GREYSTAR CAPITOL HILL

GREYSTAR C.H. DESIGN RECOMMENDATION MEETING

02.15.23 · 1410 E JOHN ST · SDCI #3038146-LU

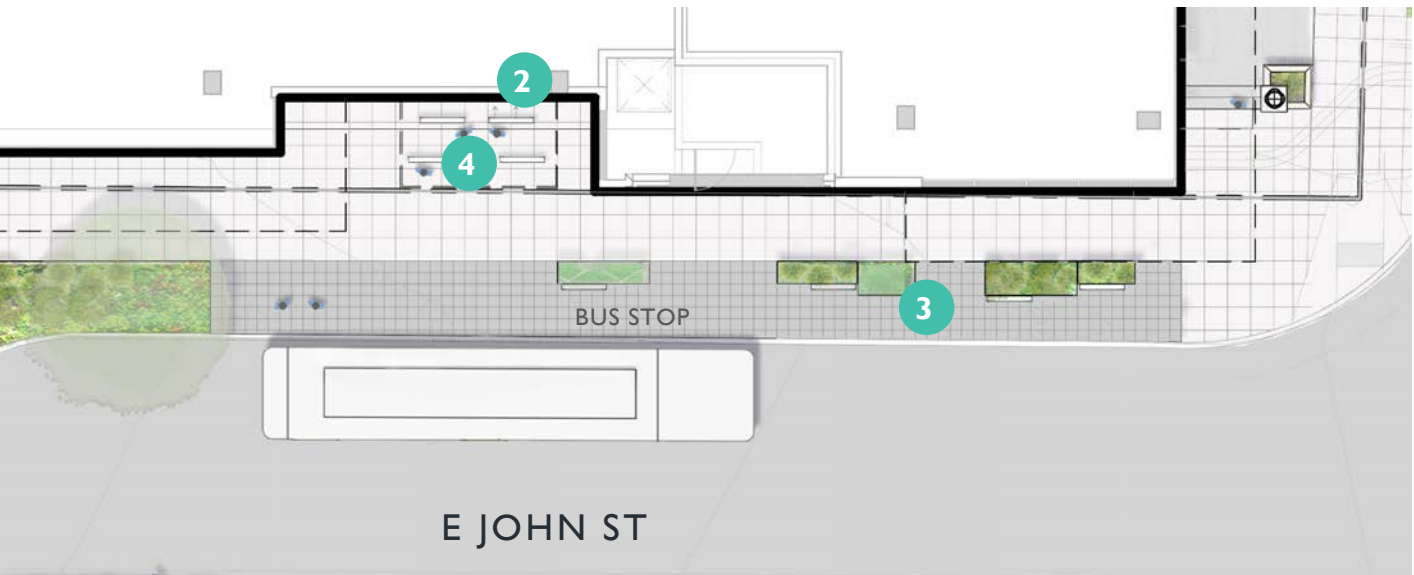
5b. The Board heard public comment and directed further study of how the bus stop is integrated into the overall design as a safe, comfortable, and functional space. (PL4, PL4-C)

Response: The massing notch incorporated into the building expands the sidewalk near the bus stop and provides seating, planting, and pedestrian scale artwork in this area (PL4-C). The grocery store has located a cafe with large amounts of glazing adjacent to the bus stop to make this space a safe, comfortable, and active location for transit users.

PEDESTRIAN EXPERIENCE – JOHN ST

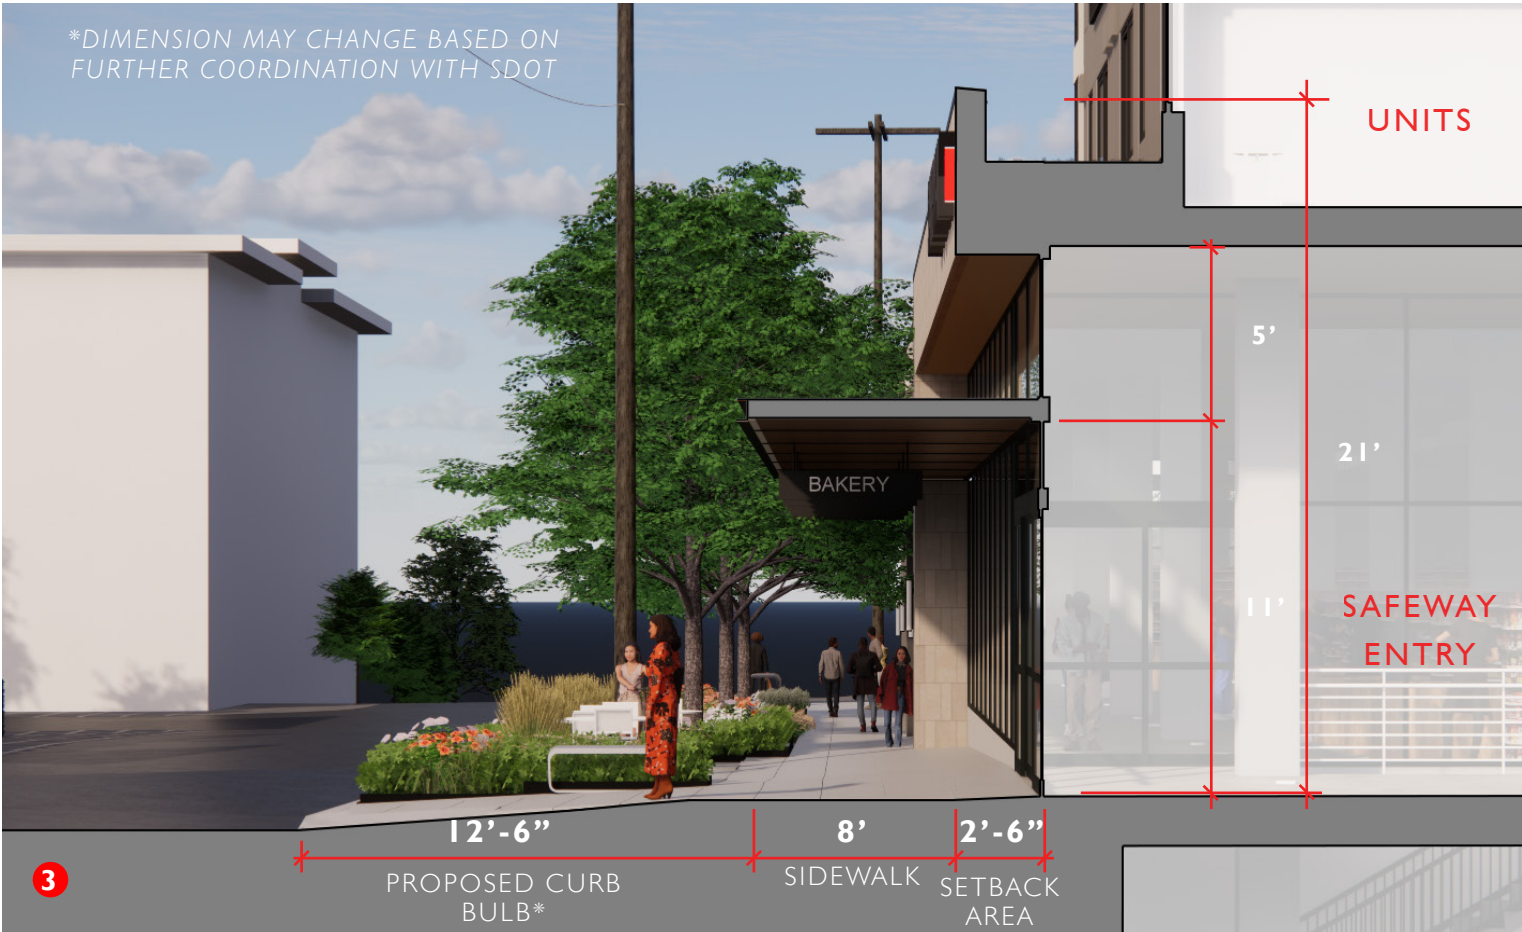
4d. In response to public comment, the Board requested more information on how the primary grocery retail entry on E John St will be designed to be welcoming, accommodate heavy pedestrian traffic, and promote connectivity with the park. (PL1-B-2, PL1-I-a, PL3, PL3-I-a)

Response: In coordination with SDOT, the proposed curb bulb at E John St expanded westward to capture both sides of E John Court, which increases the pedestrian space near the grocery entry (PL1-B-2). This expanded curb bulb will also include two striped crosswalks connecting to both sides of E John Court, enhancing the pedestrian connection between the store and Williams Place Park (PL1-B-2). The grocery entry itself will be largely transparent, with the store interiors designed such that there are no shelving or storage along E John St (PL3). The grocery entry includes a recessed area at the entry doors, with a deep canopy providing weather protection and integrated lighting (PL3-I-a).

SAFEWAY AT 14TH AVE E

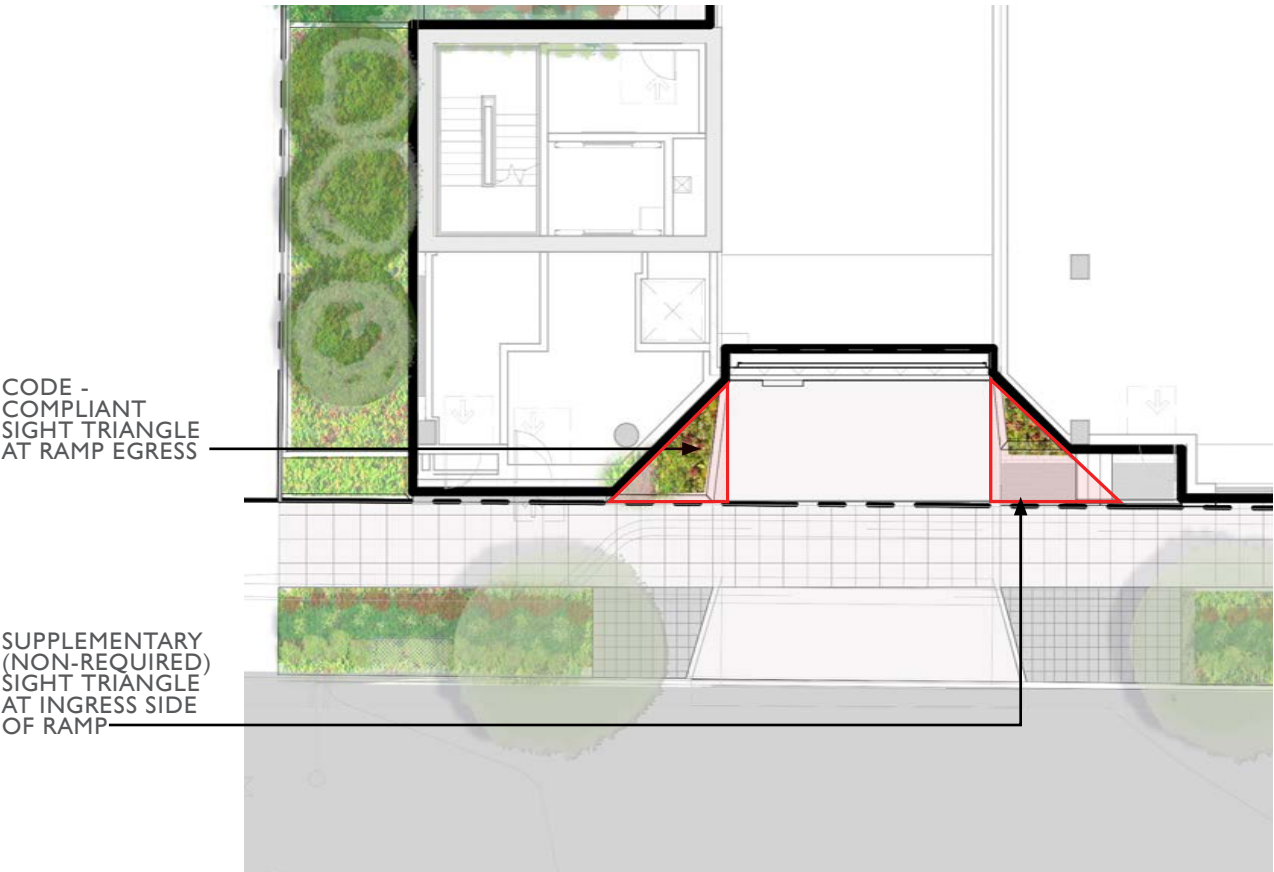
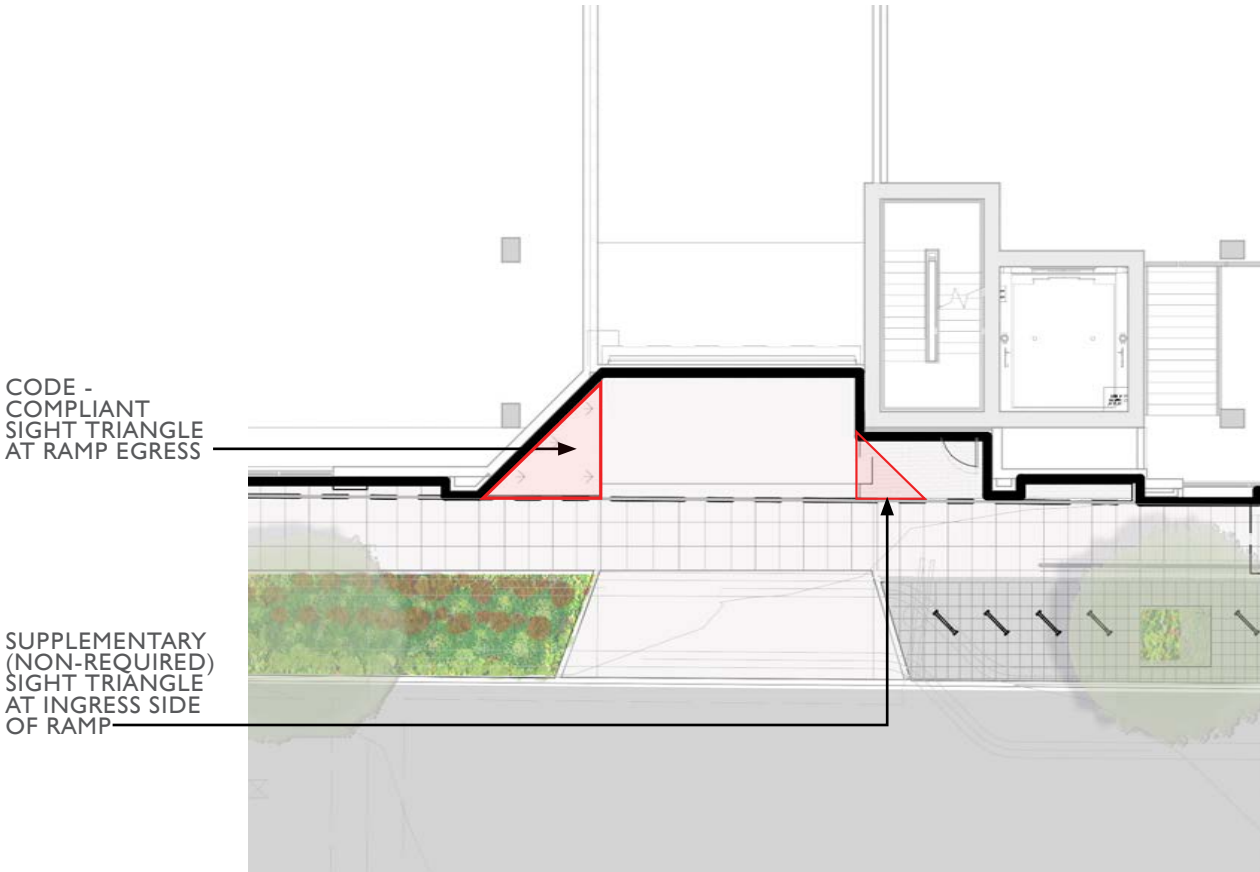
4f. In response to public comment, the Board directed further study of minimizing vehicular access impacts on the pedestrian experience and promoting safety along 14th Ave E. Suggestions included reducing the number of curb cuts to one, minimizing the width of curb cuts, providing two one-way curb cuts, etc. The Board indicated that support for the requested departure from vehicular access requirements is dependent on the resolution of this guidance. (DCI -B-1)

Response: The design team studied the following ramp scenarios:

The conclusion is to maintain the proposed two 2-way ramps and provide the following assessment:

Driveway PM peak hour trips is estimated to be approx. 280 trips (138 in, 142 out). Concentrating this volume into a single ramp will cause congestion both in the garage, and in the nearby streets. The potential for on-street queing is higher given that all traffic is trying to access the single ramp. The increased traffic queing at the street causes more conflicts in other crosswalks, specifically the crosswalk at the intersection of 14th and John. As a result, driver aggression could be amplified by potential conflicts of increased congestion.

Two vehicle access ramps also prevent customers from driving around the neighborhood in search of parking, reducing traffic jams, vehicular trips and on-street queuing, and the probability of accidents and conflicts with other vehicles, pedestrians, and bicycles. This supports neighborhood goals for urban centers and transit station areas. The requested vehicular access plan will not cause an increase in vehicular traffic as the driveway curb cuts are to provide more efficient operations.

STREET VIEW AT 14TH AVE E

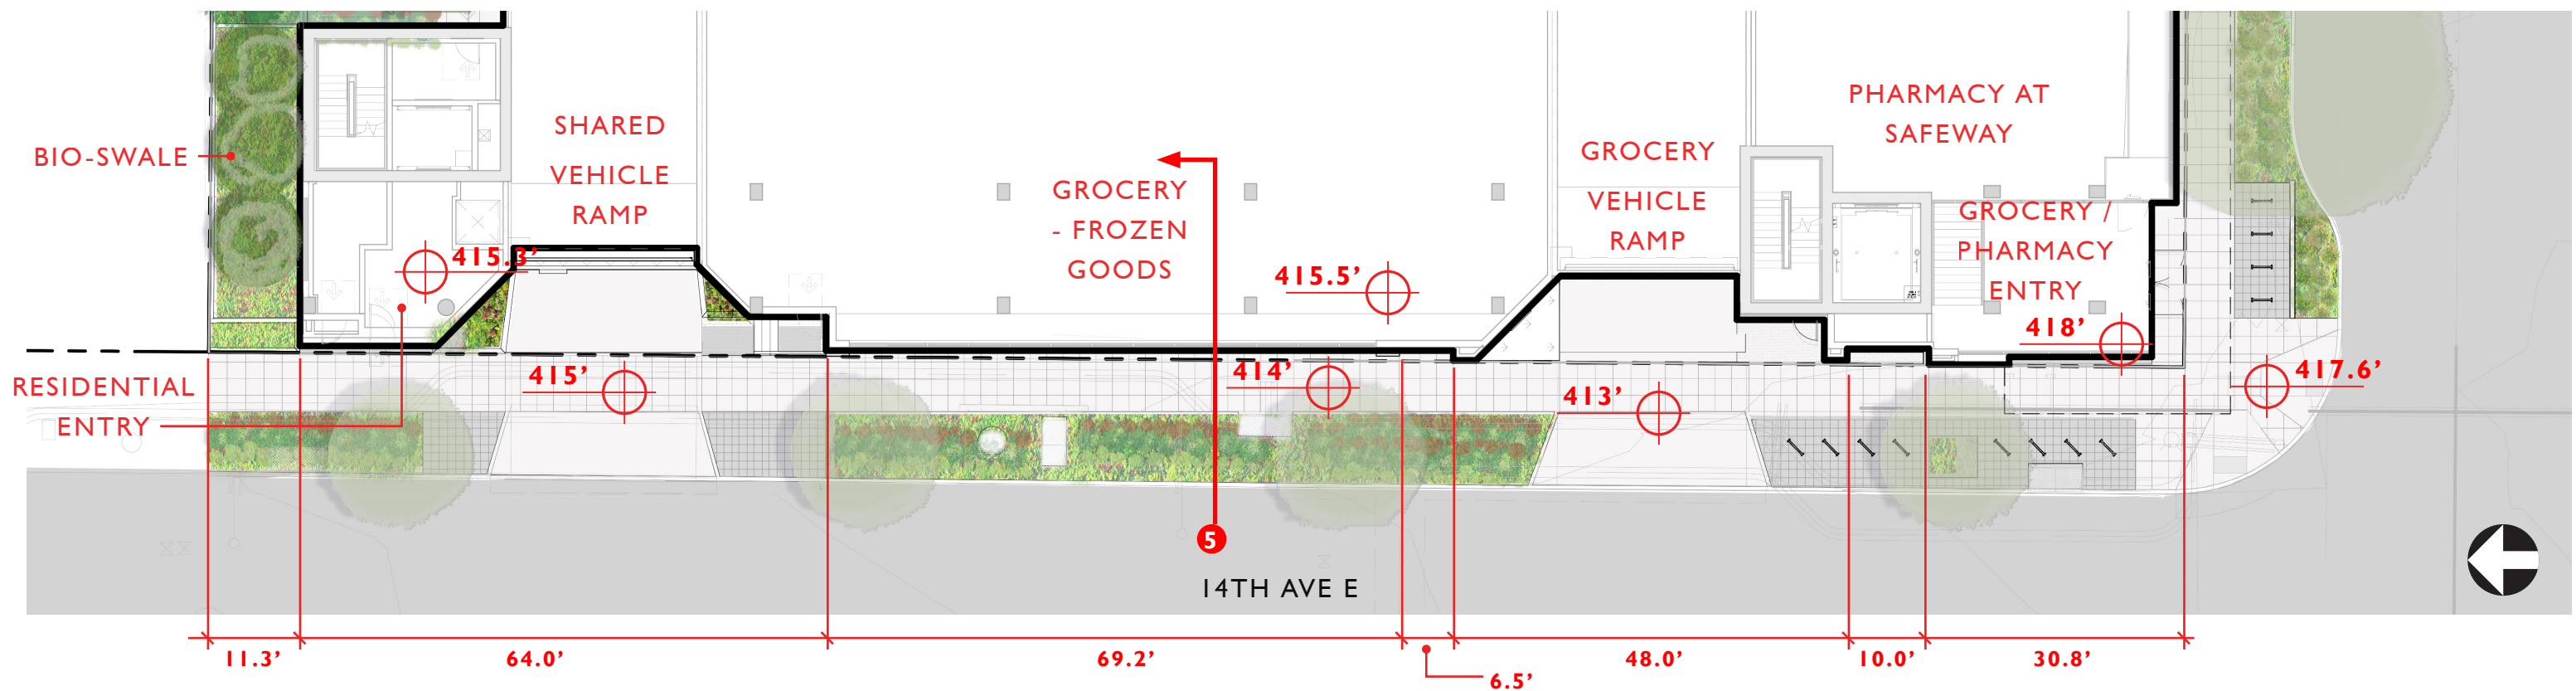
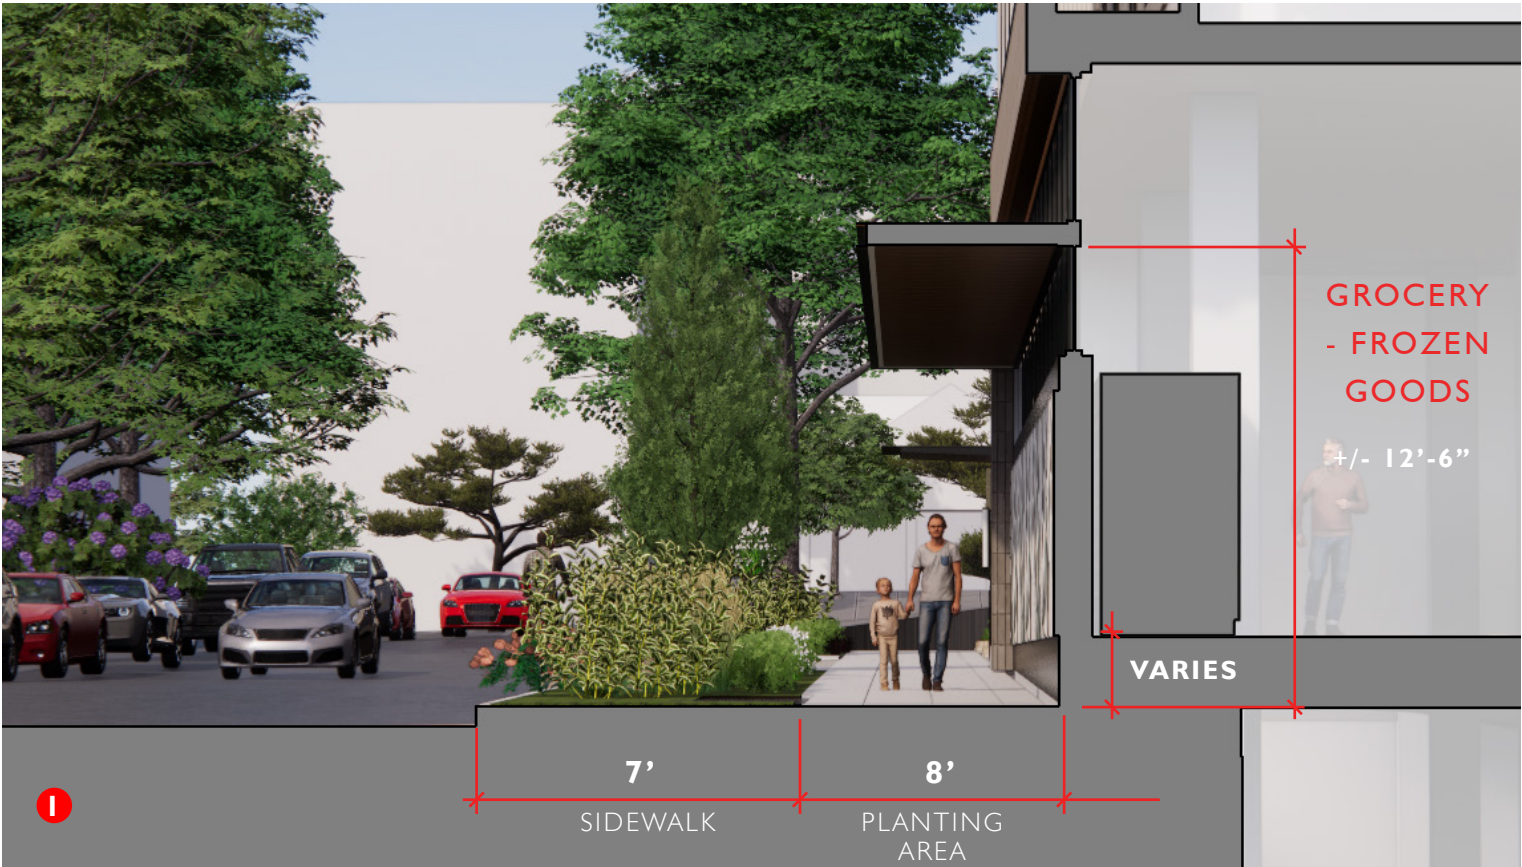
4f. In response to public comment, the Board directed further study of minimizing vehicular access impacts on the pedestrian experience and promoting safety along 14th Ave E. Suggestions included reducing the number of curb cuts to one, minimizing the width of curb cuts, providing two one-way curb cuts, etc. The Board indicated that support for the requested departure from vehicular access requirements is dependent on the resolution of this guidance. (DCI-B-1)

Response: This issue has been studied at length with the team’s traffic engineer, SDOT, and the grocery team. Based on discussions to-date, two two-way curb cuts/ramps are the best design response to prevent queuing, traffic backups, driver frustration, and safety issues. The board acknowledged the importance of maintaining a neighborhood grocery store with parking that works and understood that reducing the proposed curb cuts may not be feasible. The project is providing two code compliant curb cuts along 14th Ave E for residential and retail access to the below grade levels, similar to what was shown at EDG. While there are two ramps proposed, pedestrian safety is increased through the incorporation of 10’ x 10’ sight triangles on the egress side of the ramps (DCI-B-1) and additional sight triangles on the ingress sides of each ramp that increase visibility between pedestrians and vehicles. Like any large space, there should be two means of egress for the safety of the people in the below grade levels.

SIDEWALK VIEW LOOKING SOUTH AT 14TH AVE E

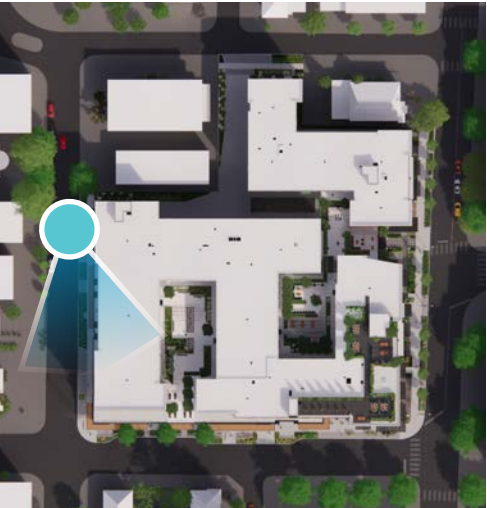
4c. The Board heard public comment and directed further study of the incorporation of a common residential entry or private stoops on E Thomas St and **a common entry on 14th Ave, to enhance the residential character in response to the context.** (CS2, PL3-B-2, PL3-I-b, PL3-I-c)

Response: The design includes a second residential entry off 14th Ave E, clad in white brick and light bronze storefront. This provides a sense of consistency of the residential entry conditions.

SIDEWALK VIEW LOOKING WEST ALONG E THOMAS ST

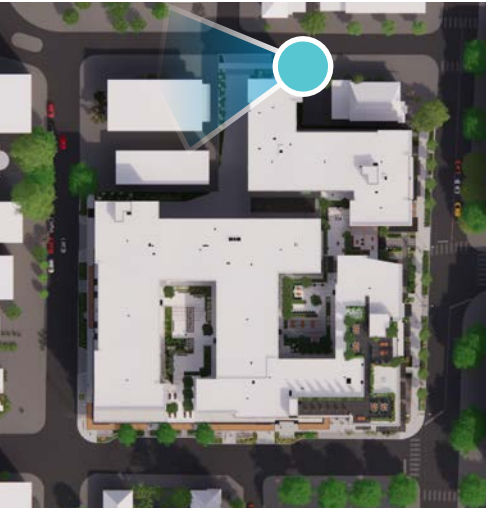
4c. The Board heard public comment and directed further **study of the incorporation of a common residential entry or private stoops on E Thomas St** and a common entry on 14th Ave, to enhance the residential character in response to the context. (CS2, PL3-B-2, PL3-I-b, PL3-I-c)

Response: A shared stoop element has been incorporated for the two units that face E Thomas St to relate to the residential character of this block. With the adjacent truck access, the shared stoop is accessed from the east, keeping residents away from trucks entering and leaving the loading area to the West. (CS2, PL3-B-2, PL3-I-b, PL3-I-c)

LEVEL 2 RESIDENTIAL COURTYARDS AND RI ROOFTOP DECK

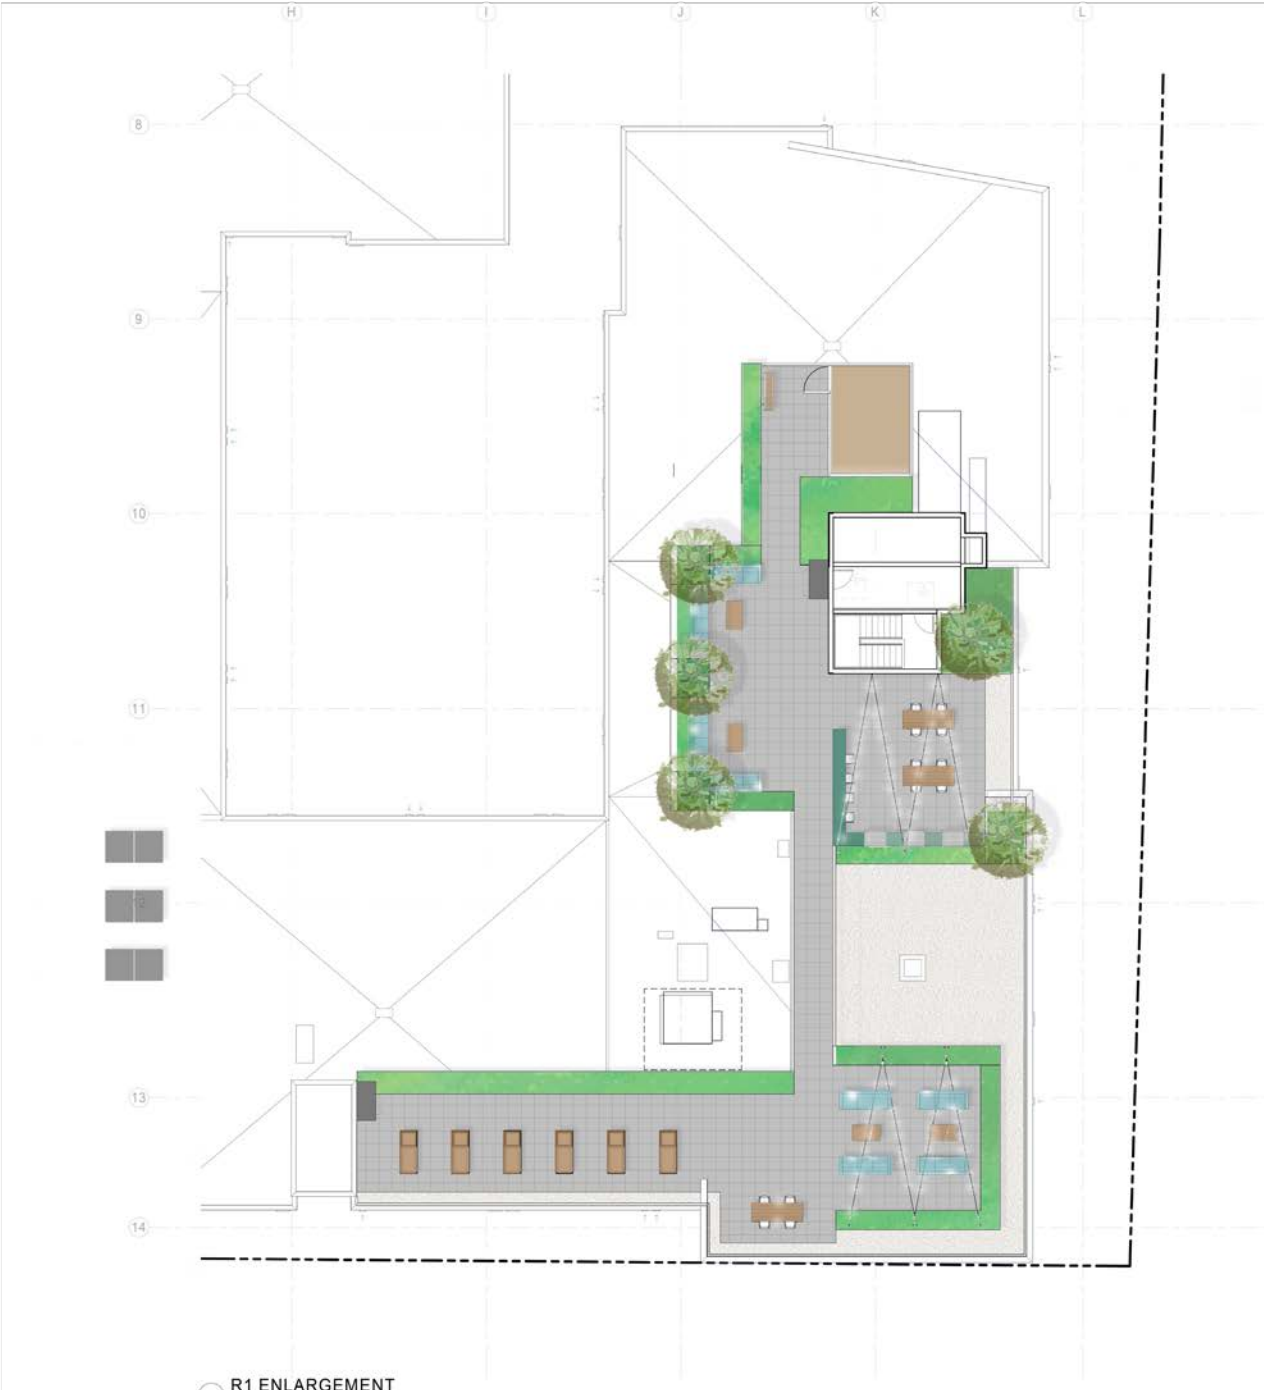
5c. The Board requested more information on the design of the rooftop and courtyards in the Recommendation packet. (DC3, DC3-C)

Response: Detailed plans/sections/rendered views are included at this Recommendation phase (DC3, DC3-C).
